USNRC APPLICATION
SUA-1341 License Amendment
Ludeman Project
Converse County, WY

June 2013

100 Sand Potentiometric Map
Ludeman Regional Aquifer Test
Uranium One America
Converse County, Wyoming
Revised June 2013

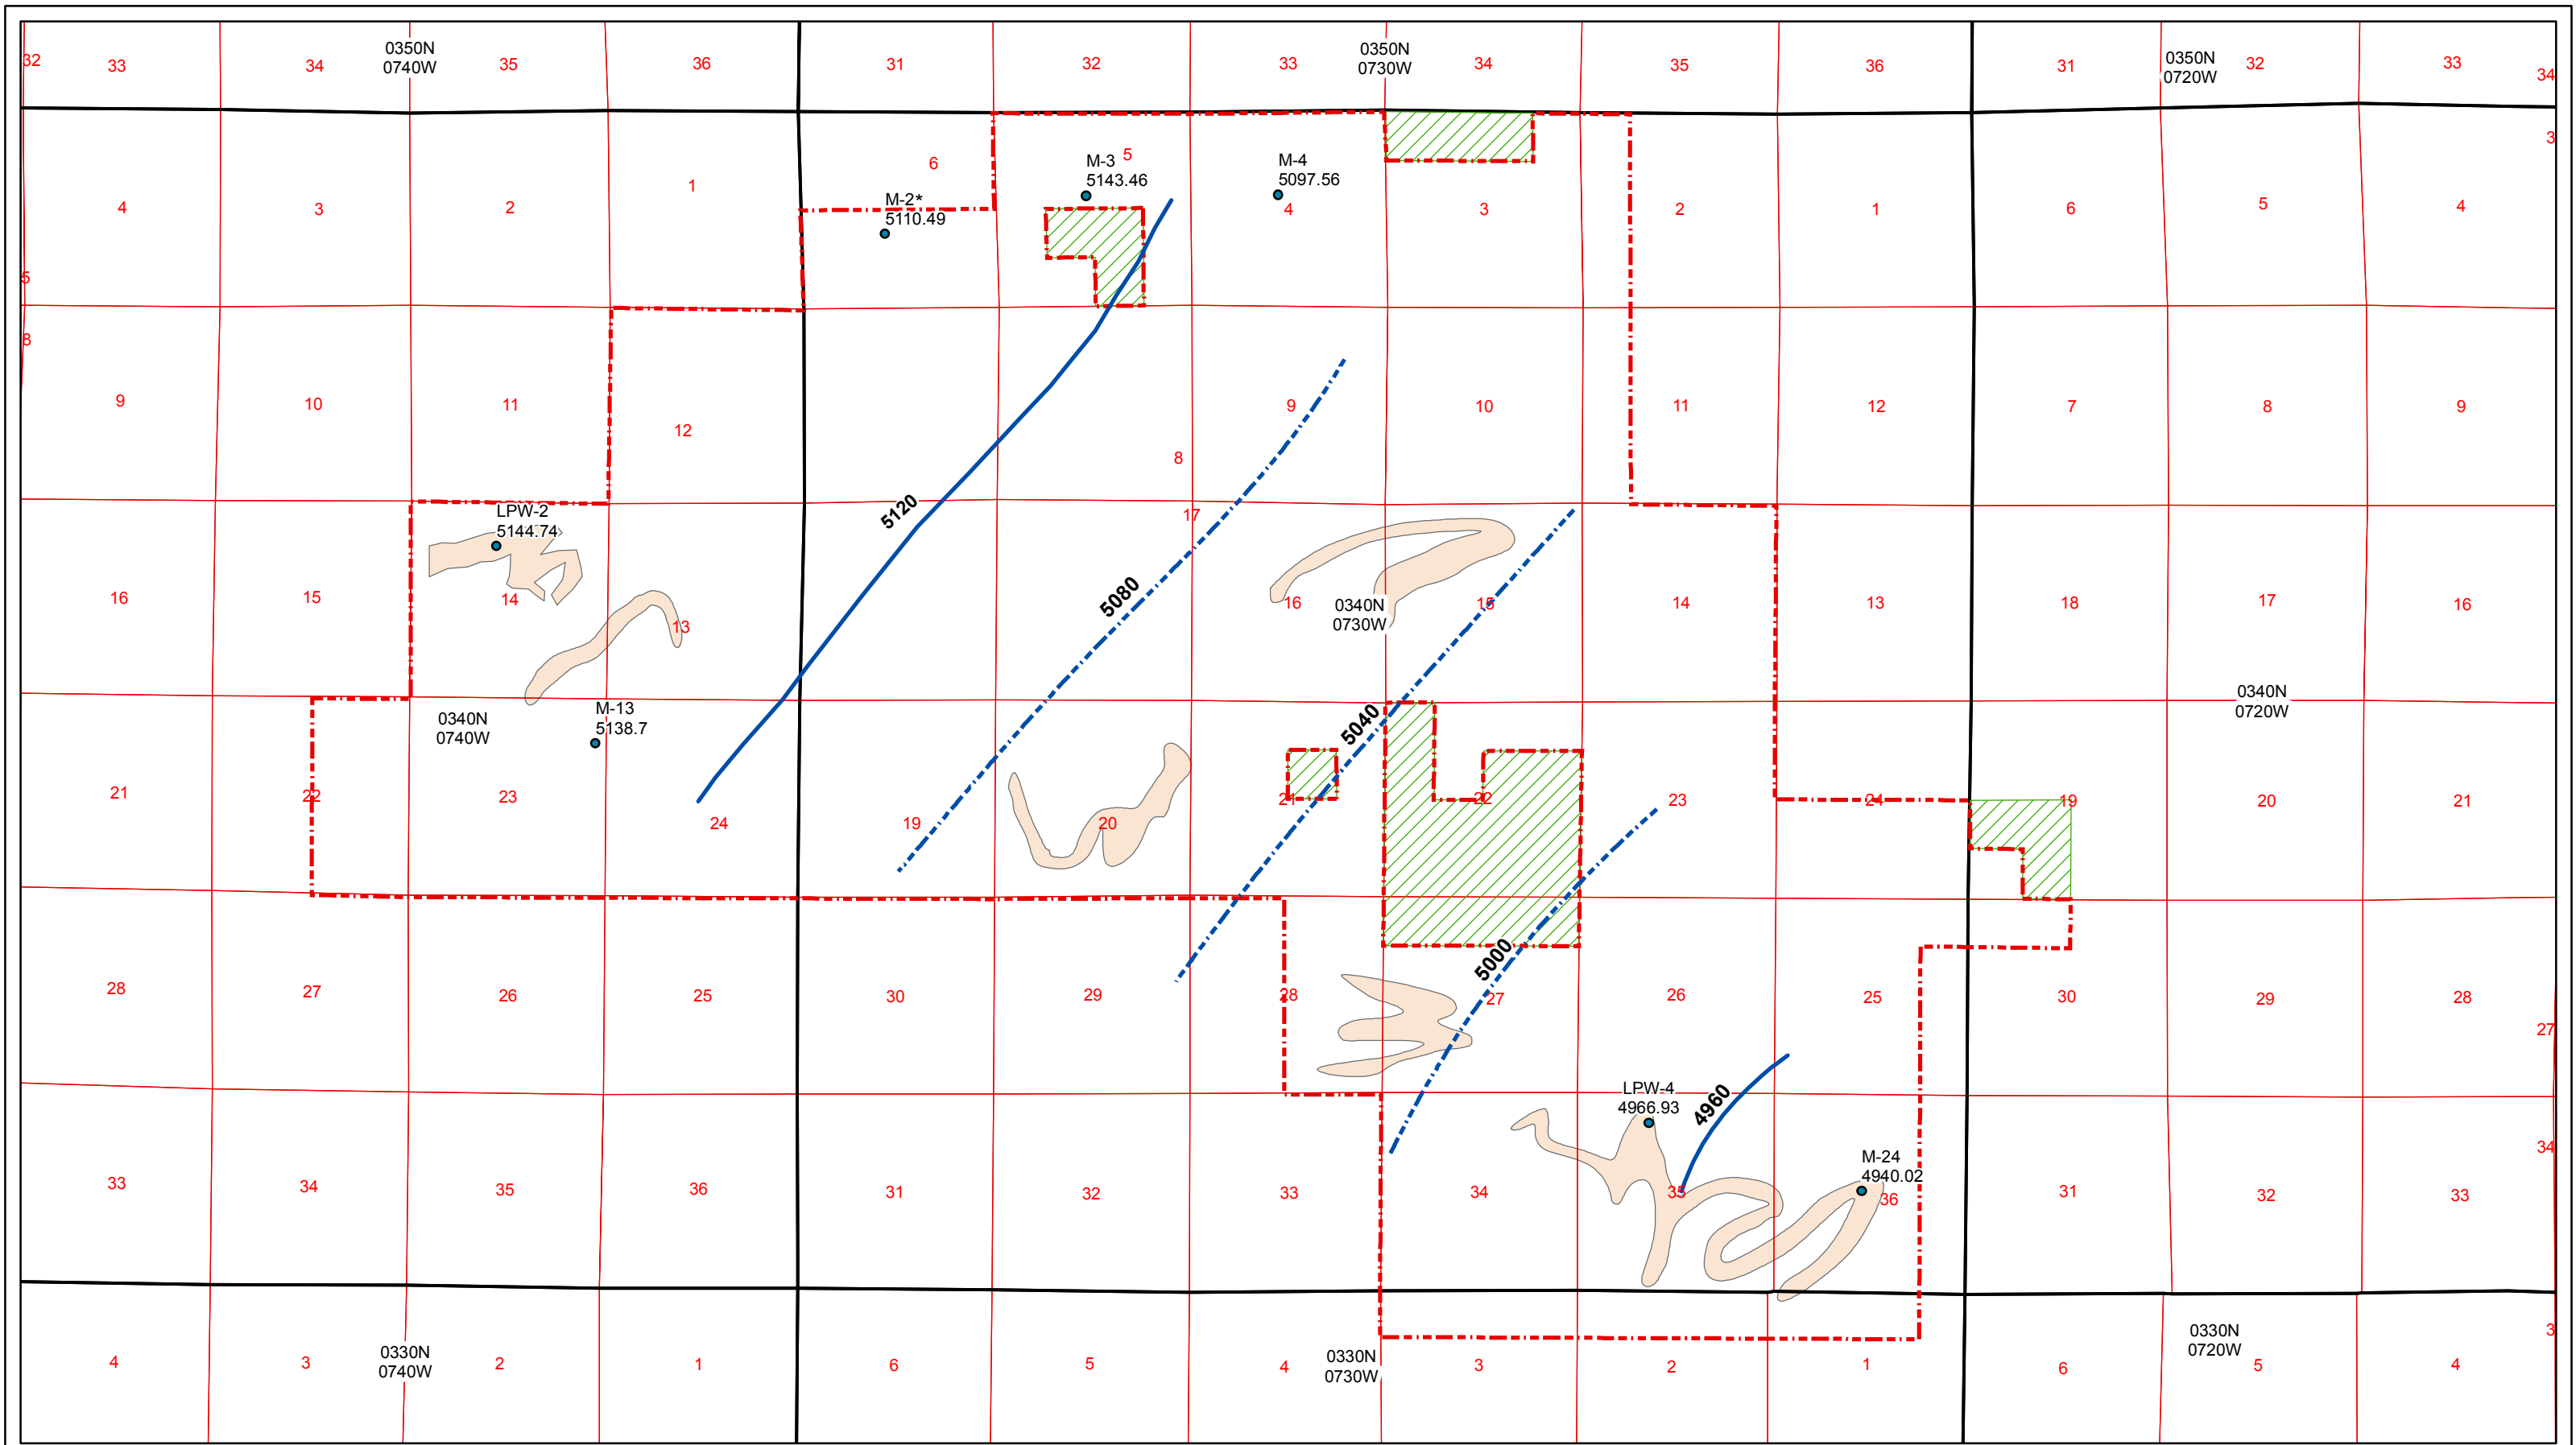
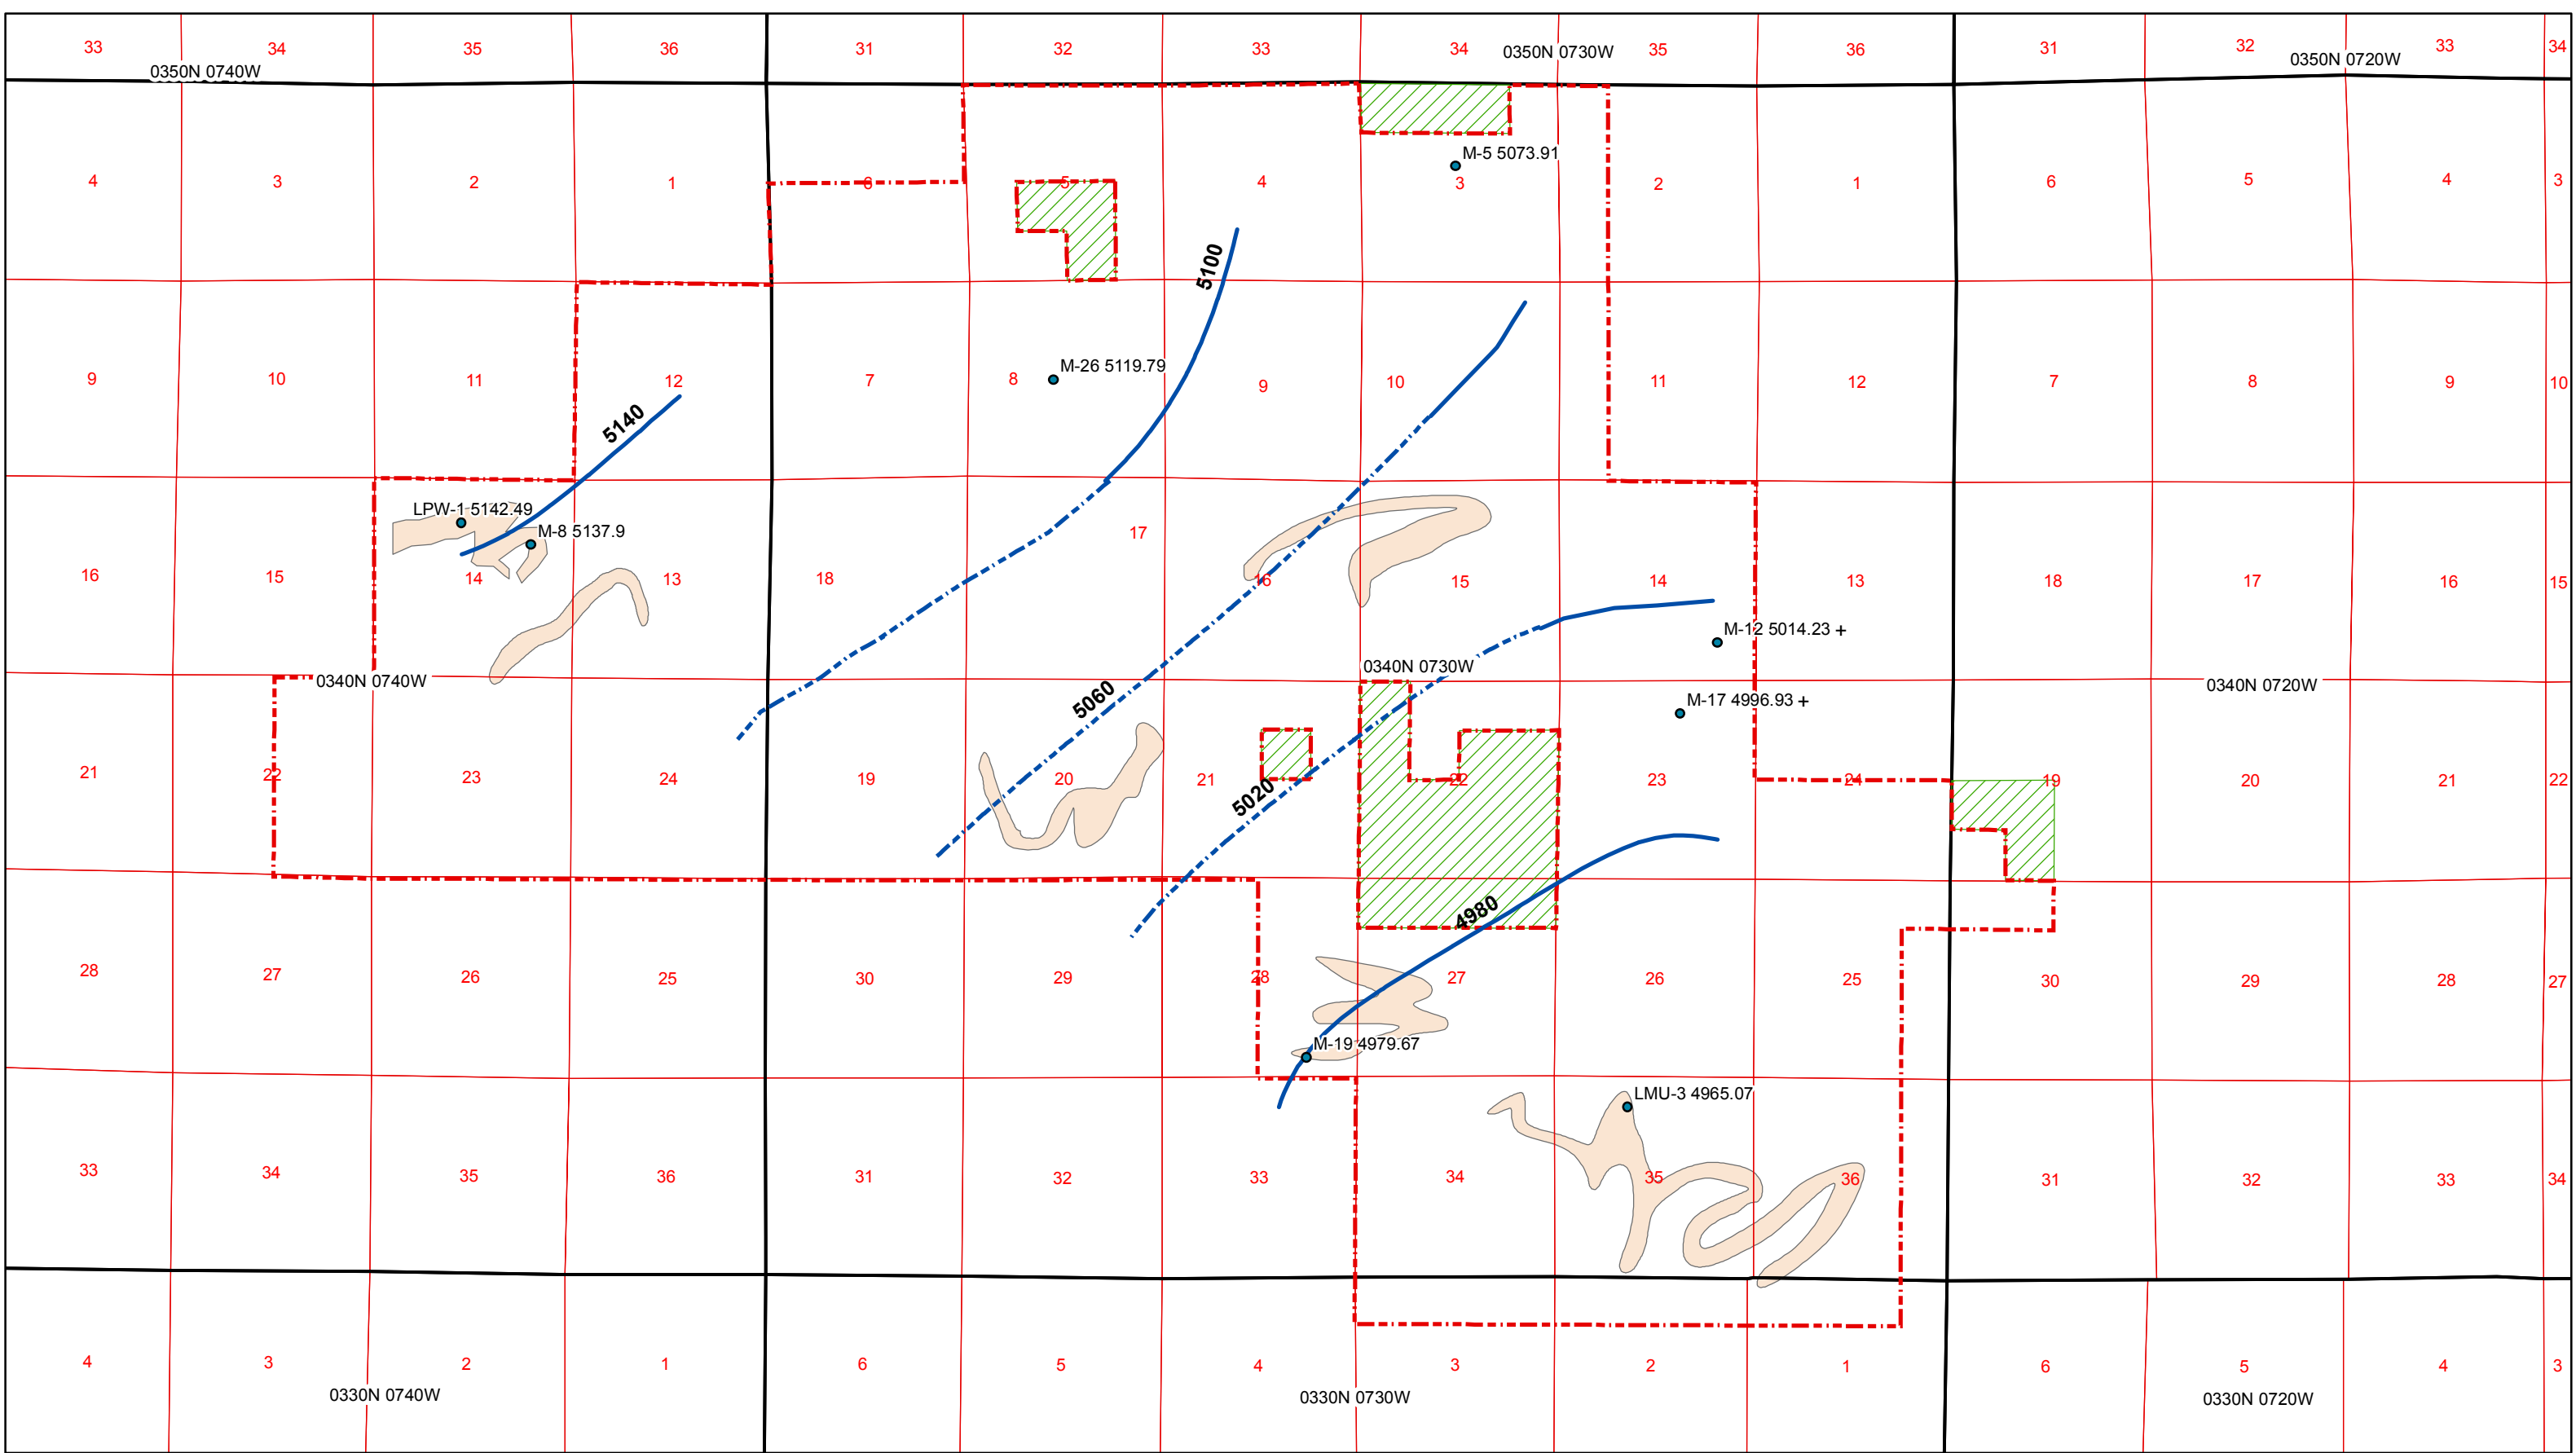
Staff evaluated the Addendum 2.7-C table “Summary of Monitoring Well Completions” and found the majority of the well top of casing (TOC) elevations in the tables were in conflict with well log ground surface elevations of the same wells provided in the cross sections in Figures 2.6-3 through 2.6-13. The table below presents the monitoring well top of casing elevations provided Addendum 2.7-C vs. the elevations provided on the cross sections. As can be seen in the table, there are often very large differences in the elevations. These differences call into question the aquifer water levels in mean sea level which were calculated based on the top of casing elevation. These water elevations are the basis for the potentiometric surfaces created for all the aquifers in the proposed license area. In addition, the selection of aquifer sand location is questionable if the well TOC elevation is inaccurate. Because of these errors, staff was unable to evaluate the potentiometric surfaces, ground water flow direction and magnitude for the Leuenberger, North Platte or Peterson Satellites. Staff is also unsure if Uranium One has made the appropriate identification for the location of the underlying sands and aquitards based on the elevation errors. Staff cannot evaluate or provide reasonable assurance for the safety of operations at any of the proposed satellites without correction of the elevations of these monitoring wells and all figures and calculations (e.g. sand top and thickness) which were based on them.

Uranium One should correct all monitoring well elevations noted to be in error on the table and correct all discussions, tables, maps, cross sections and isopachs which used the incorrect elevation information from these monitoring wells. In addition, Uranium One should ensure that all well surface elevations presented in the application are accurate and all calculations based on them are also accurate. Staff is especially concerned about the correction of the elevation of the overlying aquifer sand, ore zone aquifer sand, underlying aquifer sand and associated aquitards at each satellite.

Additionally, staff is very concerned about the potentiometric surfaces and vertical gradients between aquifers which were calculated based on these elevations. Staff notes that anomalous potentiometric surface mounds were associated with some of these elevation errors. Therefore, once corrections are made to the elevations, provide the corrected potentiometric surfaces and estimate the ground water flow magnitude and direction for all overlying aquifers, ore zone aquifers and underlying aquifers for the Leuenberger, North Platte, and Peterson Satellites. Uranium One should use available water levels from wells located within 2 km of the each satellite's proposed wellfields for these updated surfaces, not just the limited monitoring wells available to provide better estimates of ground water flow direction and magnitude.

Uranium One has updated the well elevations presented in Addendum 2.7-C Summary of Well Completions with survey data and subsequently the potentiometric maps. For the wells that did not have survey data available, NED elevations have been utilized. The review of the NED elevations versus the survey elevations showed that the NED data were quite close. Thus, in cases when new survey data were not available, the NED data should provide a good approximation of elevation. The cross sections and isopachs will not require updates as they utilized the survey data to develop the figures.

The updated potentiometric maps are shown below.
